# ADDENDUM NO. 1

PROJECT: 2023 Henryville Flooring Replacement

Phase 2 & Cafeteria Expansion

ARCHITECT'S PROJECT NO.: 21-47.007

Demolition Plan

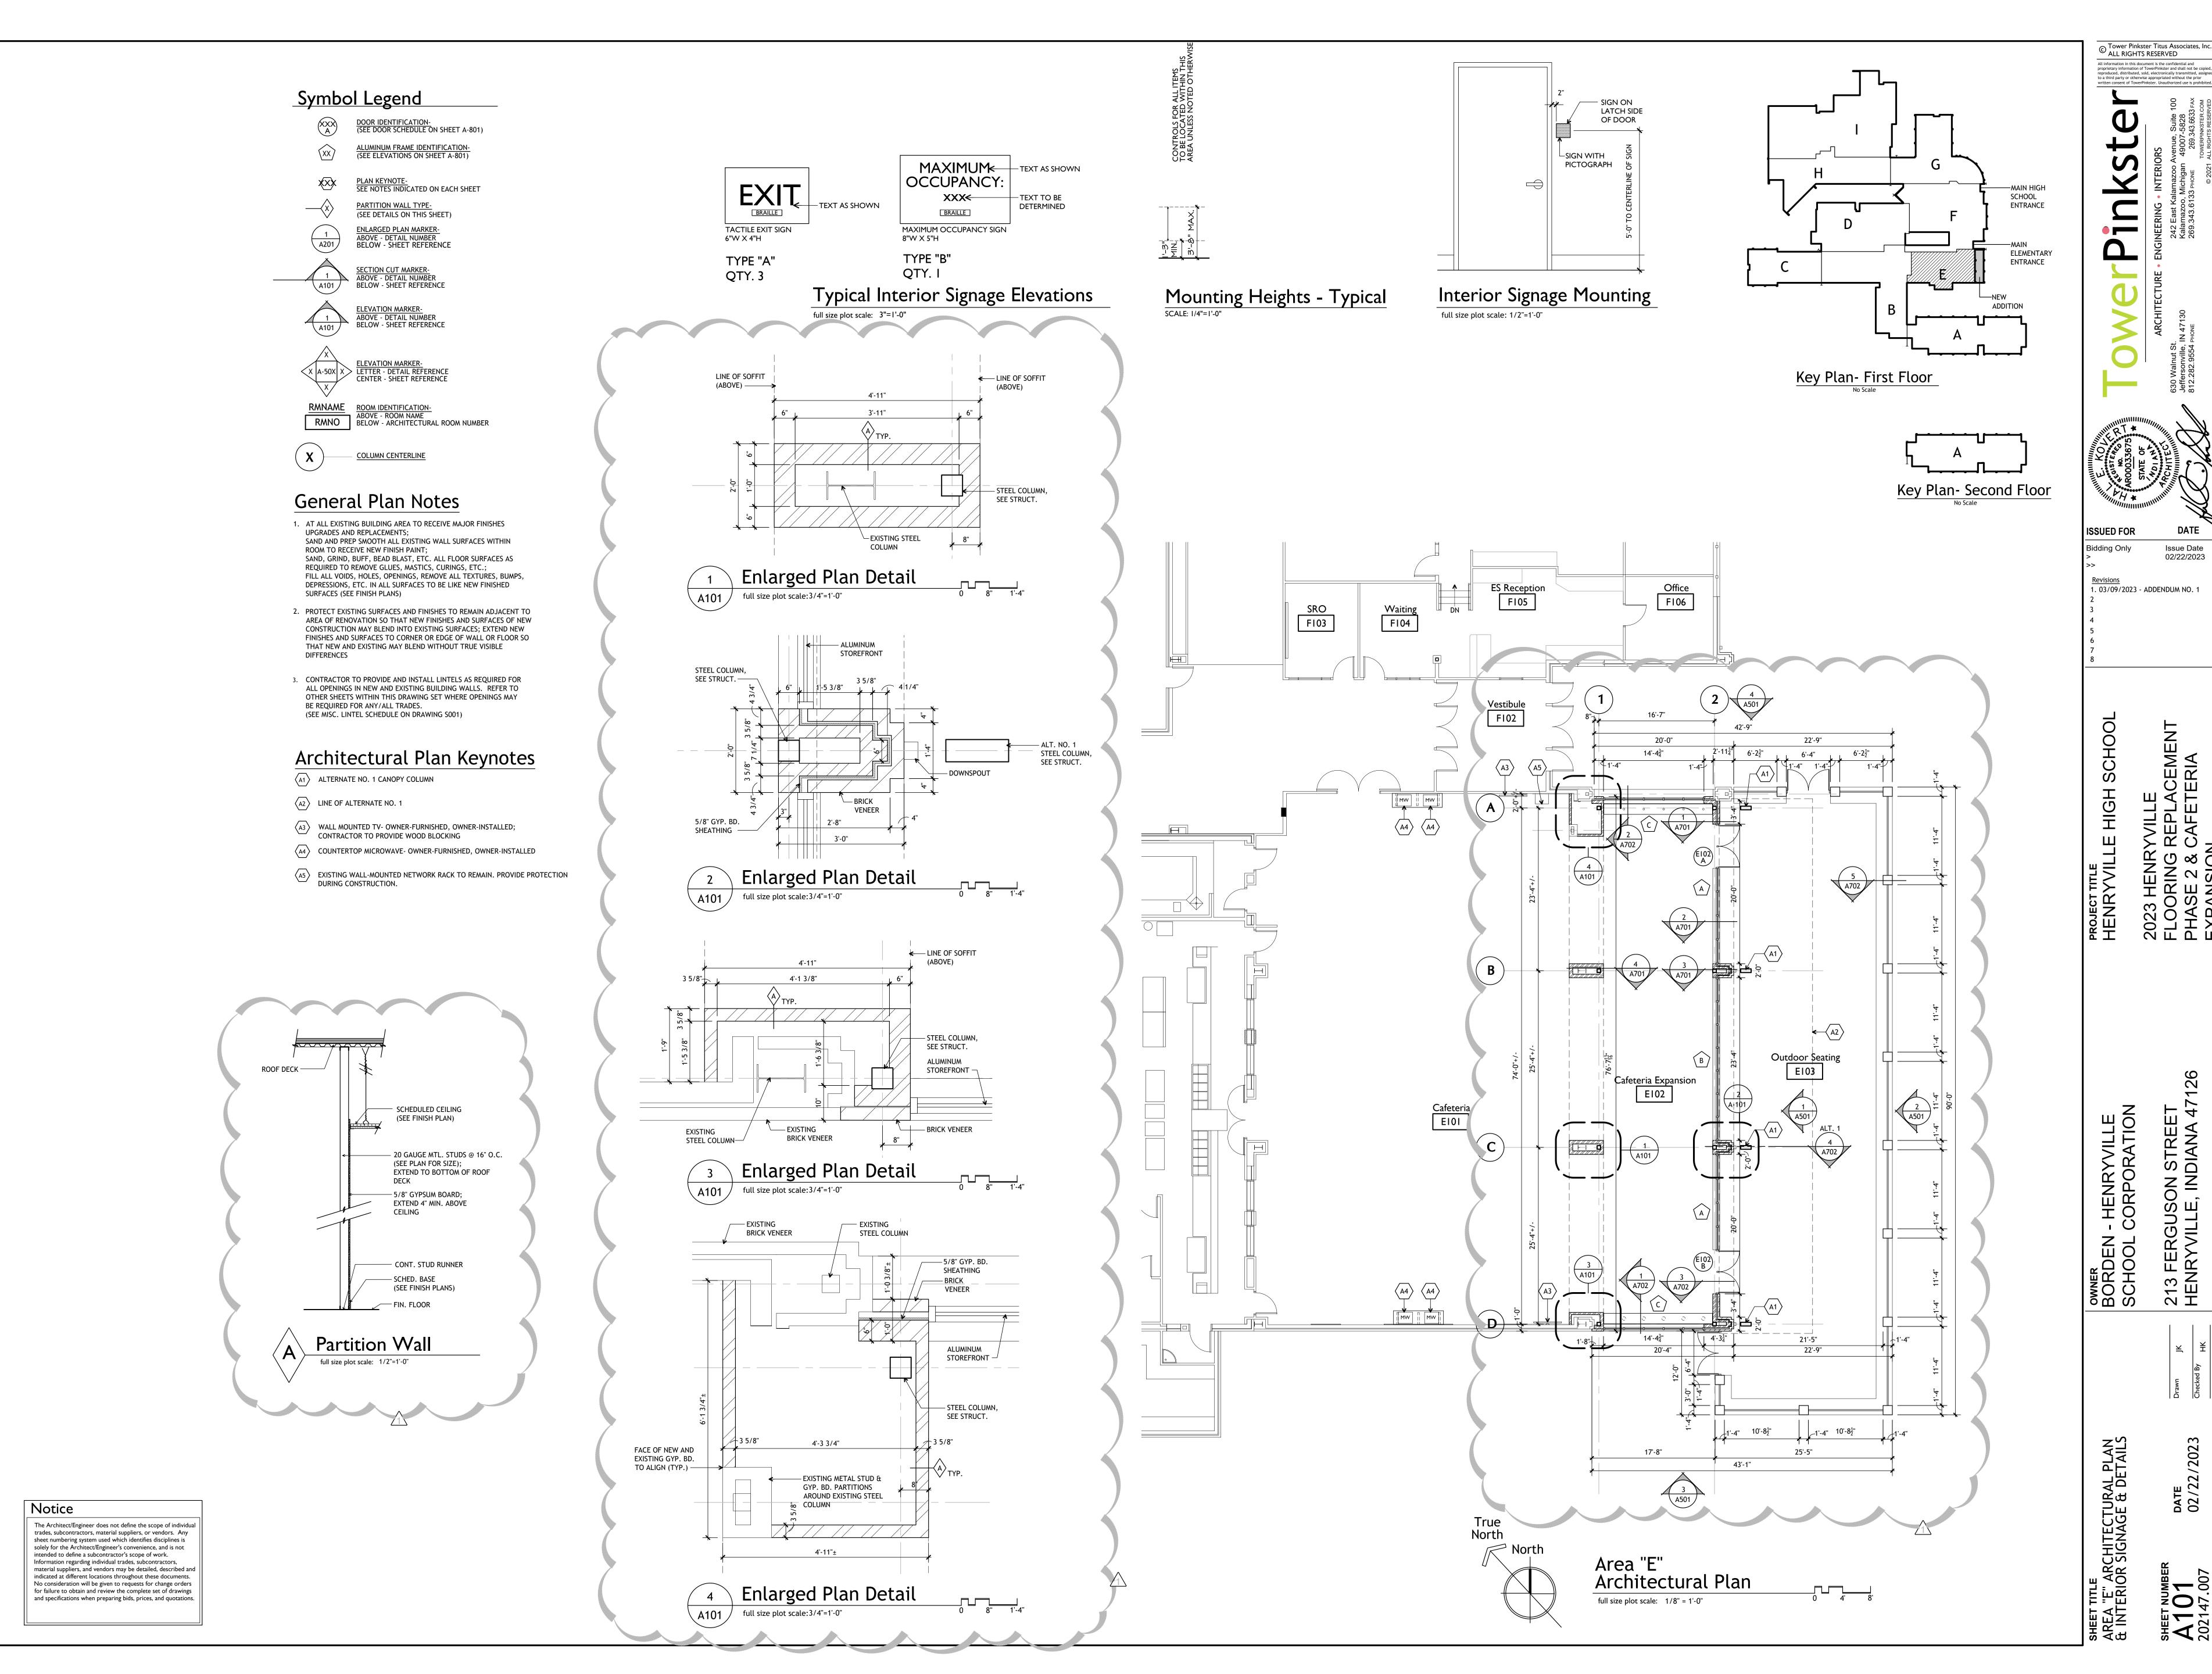
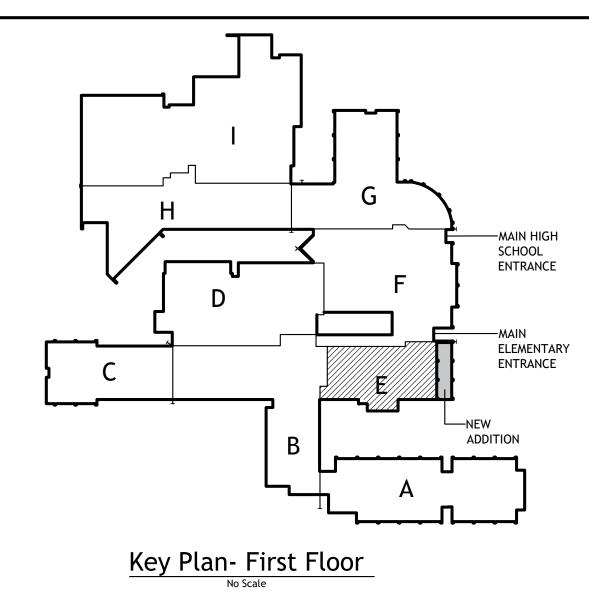
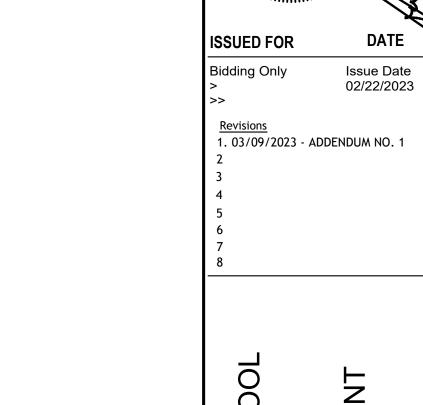
### ADD-1 Item No. D-1 - Area E Demolition

Refer to Sheet(s): A-004

Replace with attached revised Drawing in its entirety; revisions for graphic clarity have been clouded for reference.
